AGENDA
ST. TAMMANY PARISH PLANNING COMMISSION MEETING
6:00PM – TUESDAY, MARCH 13, 2018
ST. TAMMANY PARISH GOVERNMENT COMPLEX
PARISH COUNCIL CHAMBERS
21490 KOOP DRIVE, MANDEVILLE, LOUISIANA

**AGENDA
ST. TAMMANY PARISH PLANNING COMMISSION
MARCH 13, 2018
MANDEVILLE, LOUISIANA**

**CUL-DE-SAC LOT
 FRONTAGE
 WAIVER EXHIBIT**

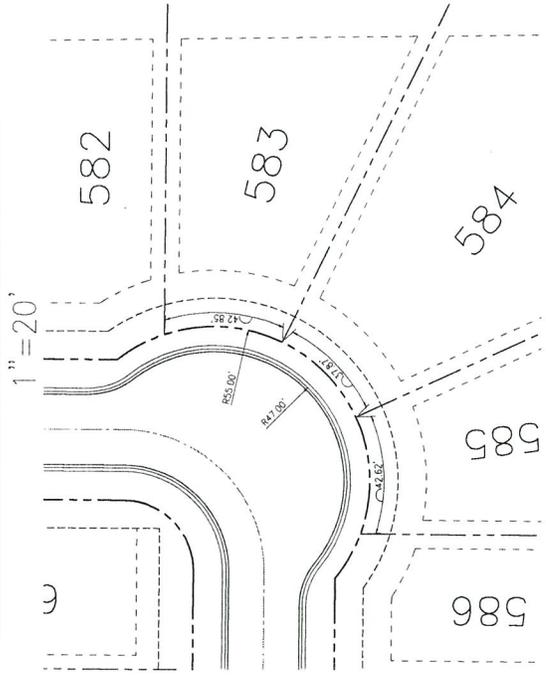
The Subdivision Regulations Chapter 125 Section 83 states that for a lot having a zoning of A-4, which is the smallest lot the Parish allows, is required to have a minimum lot frontage of 60' along the right-of-way (ROW) of a cul-de-sac. The project in question has a PUD zoning, however we are required to meet minimum standards put forth by the Subdivision Regulations. We are requesting a waiver to decrease the minimum lot frontage along a cul-de-sac from 60' to 37' for lots 610 and 584 and from 60' to greater than 39' for the remainder of the cul-de-sac lots.

The developer is requesting this waiver based on the precedent that was set in Phase 1A just south of the proposed Phase 3. Based on the final subdivision plat for Lakeshore Villages Phase 1A, there are a few lots that show a lot frontage as low as 33.41'. These lots are highlighted in the following enclosure. Therefore, the proposed lot layout of Phase 3 is surpassing what has been permitted and constructed in Phase 1A.

A SURVEY MAP SHOWING THE REMOVAL OF A 5' NO ACCESS SERVITUDE ON LOT 434 & LOT 435, MONEY HILL PLANTATION, PH. 4A ST. TAMMANY PARISH, LOUISIANA

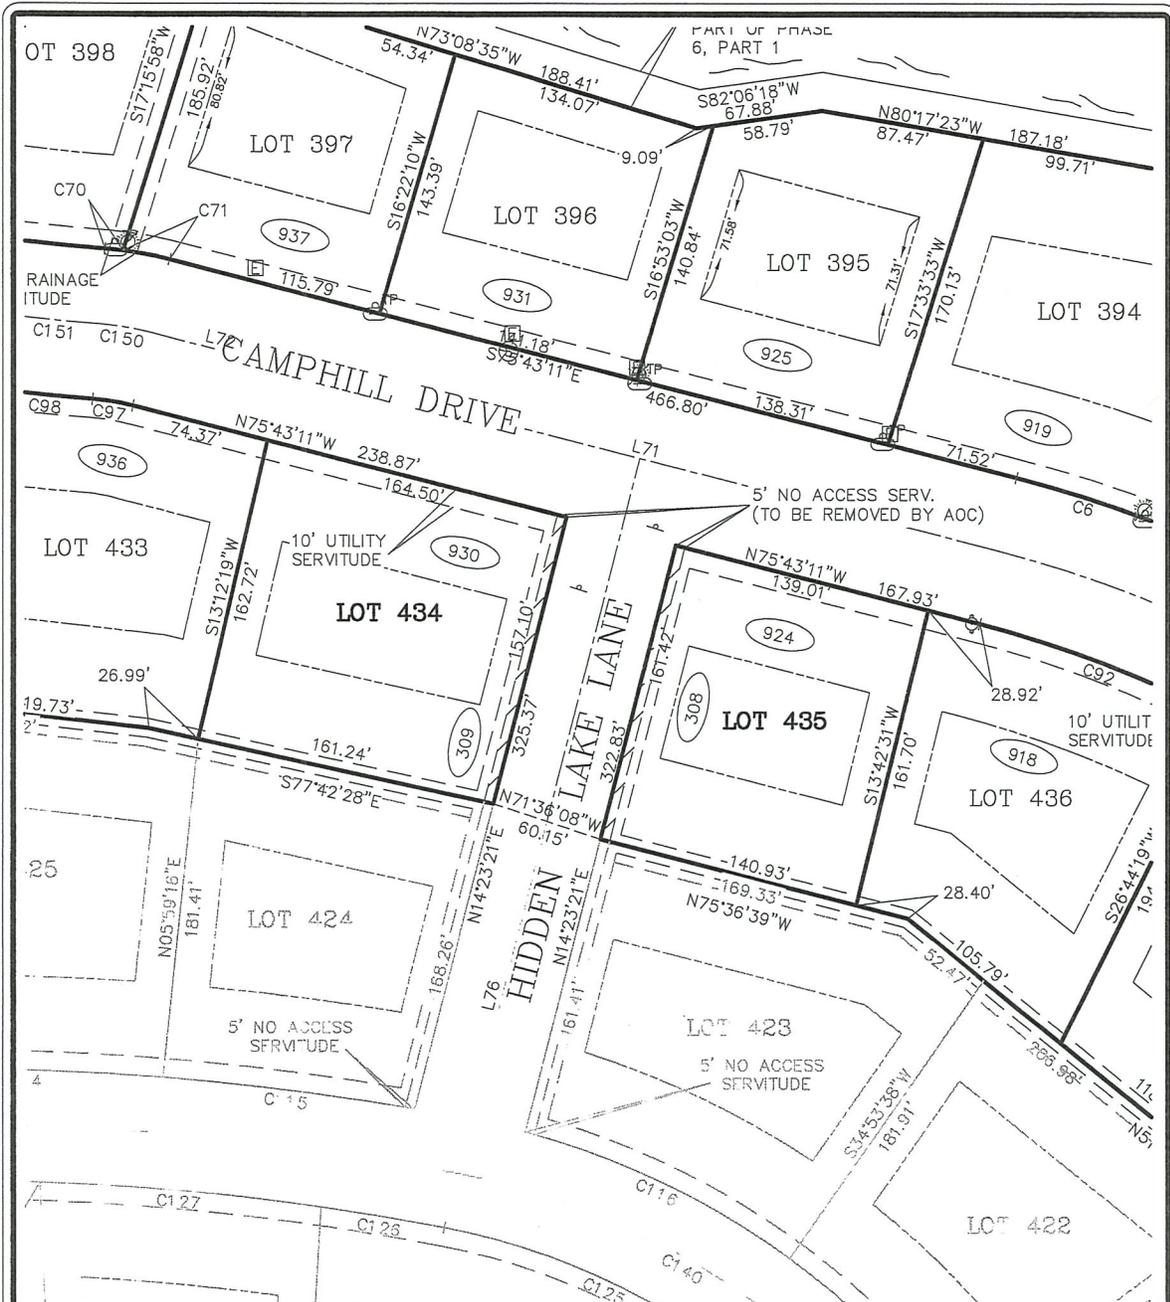
Money Hill Plantation LLC requests an amendment to eliminate the 5' access servitude on lots #423, #424, #434 and #435 because the purchasers and potential buyers of these corner properties would greatly benefit from being able to access their garages from a side entry. This will also decrease the number of driveways on Camphill Drive, so it is believed this change will improve overall traffic patterns for all.

THEREFORE, the "Surveyor" and "Parish of St. Tammany" do hereby agree through this Surveyor's Act of Correction, to amend the final subdivision plat of Money Hill Subdivision to remove the 5' no access servitude as referenced to above; and do hereby request the Clerk of Court for the Parish of St. Tammany, Louisiana, to make mention of this Surveyor's Act of Correction within the margin of the official records on the final subdivision plat, Map File No. 5320, to serve as occasion may require.

PROJECT NO.	14662 PL DRAIN.dwg
DATE	12/15/24
DRAWN BY	BAF
CHECKED BY	JEP
SCALE	1" = 100'
DATE	03/17/15
BY	JEP

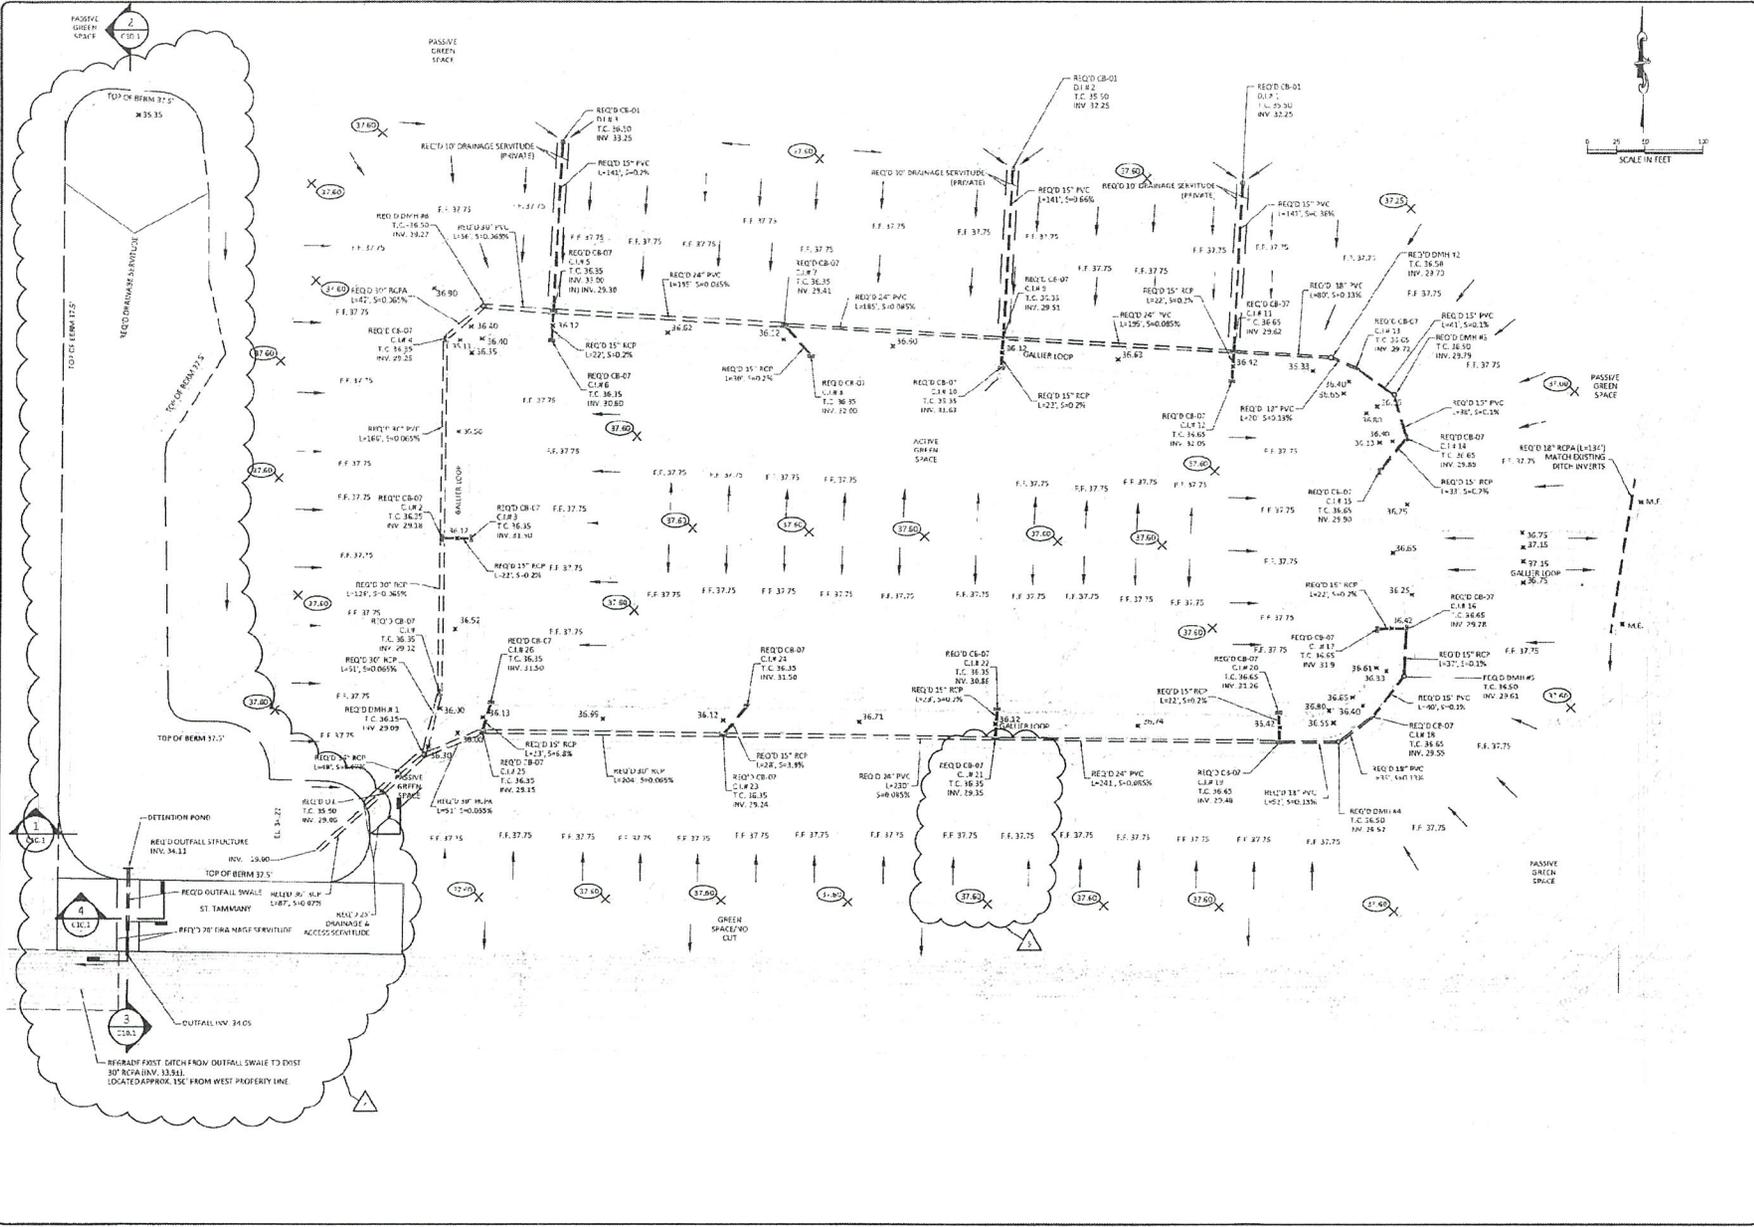
Sheet C4.0:

11. Need pond x-section
12. Need x-section of Hwy 190 ditch improvements
13. Street elevations at cross culverts are too low with respect to T.C.
14. Metal pipe is not acceptable for a surcharged system
15. RCP is needed under roadway for inlet pipe
16. Remove pipe under pavement running parallel with road
17. Show all drainage servitudes
18. Show pond servitude
19. Label all parcels
20. Need typical detail of road nipple at turns

Volume Summary							
Name	Type	Cut Factor	Fill Factor	2d Area (Sq. Ft.)	Cut (Cu. Yd.)	Fill (Cu. Yd.)	Net (Cu. Yd.)
Surface-CutFill-Design	full	1.000	1.000	834959.20	6347.53	11010.43	4662.90<Fill>

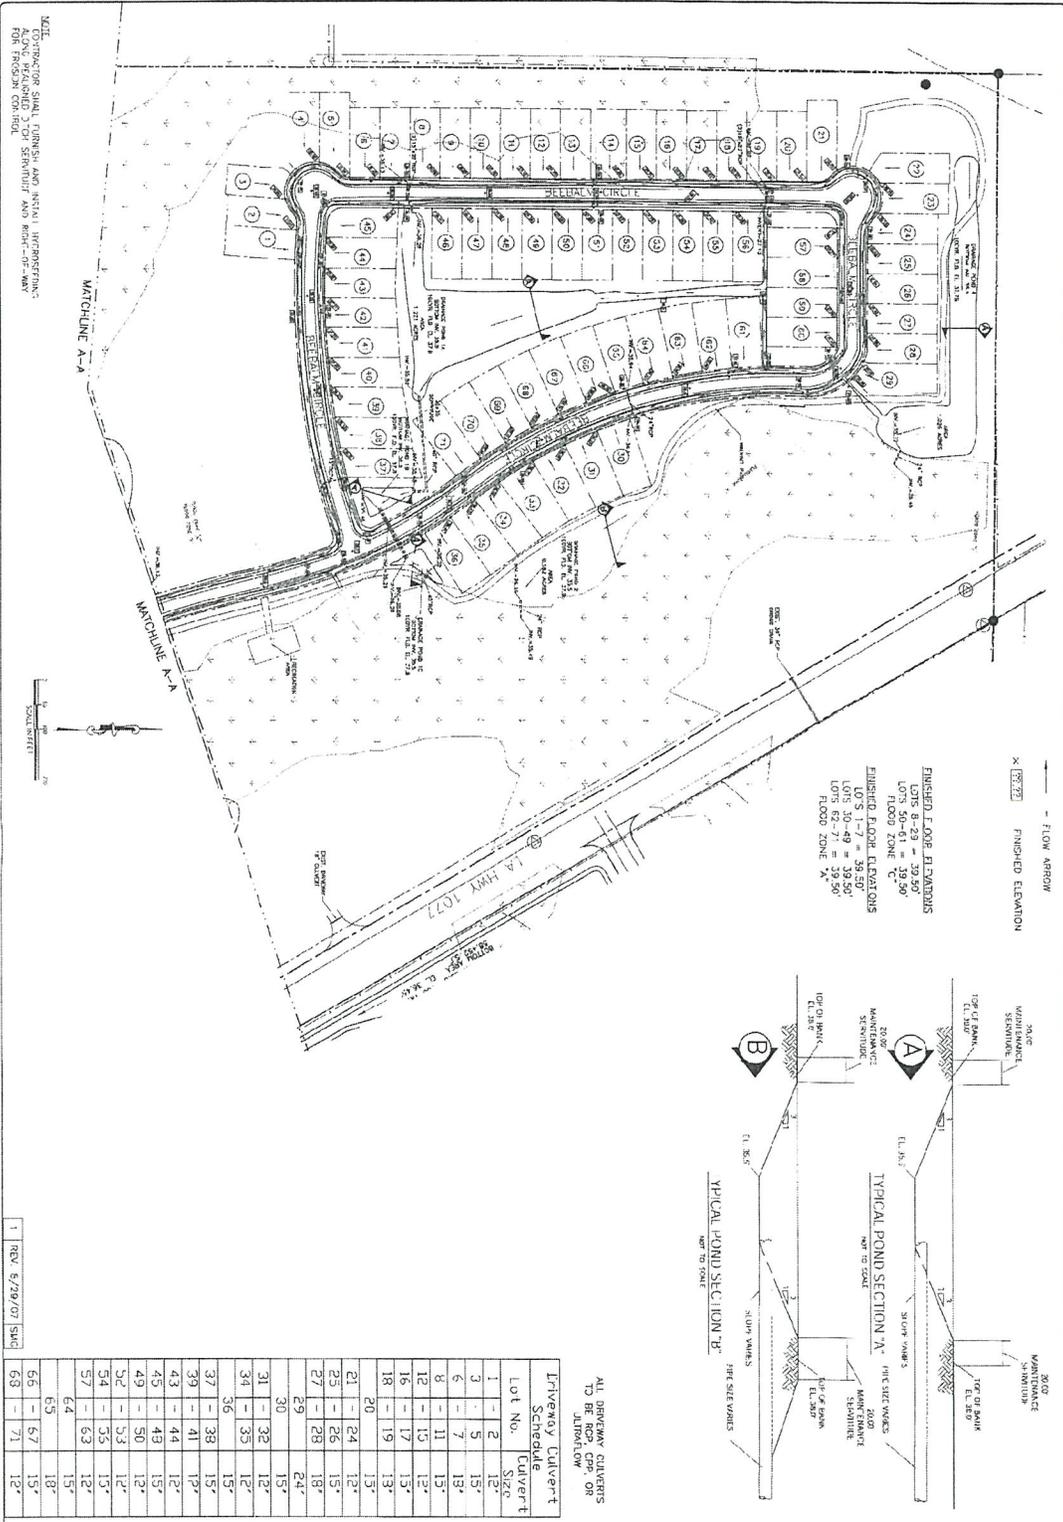
Comment No. 8 reads as follows: "Certify that the cut volume from the pond mitigates the fill required to bring all lots up to the 100 year flood elevation."

- a. Cut/Fill Calculations for Goodbee Square, Phase 1 using the pre-construction existing elevations and the as-built elevations indicate there is a net fill amount of 4,663 c.y.
- b. If said net fill amount (4,663 c.y.) in Goodbee Square is subtracted from the Countryside aggregate cut volume (13,395 c.y.), with other adjustments, then there still remains approximately 4,932 c.y. of additional floodplain storage.
- c. October 10, 2017 Email of Eddie Powell to Jay Watson, stating that all of the fill work for this project has been done in accordance with the Parish-approved plans and work orders issued, and that at no time during the review process were cut/fill calculations requested by the Parish.
- d. October 4, 2017 Email of Kenny Wortmann of STP to Mr. And Mrs. Randy Morgan, stating that:
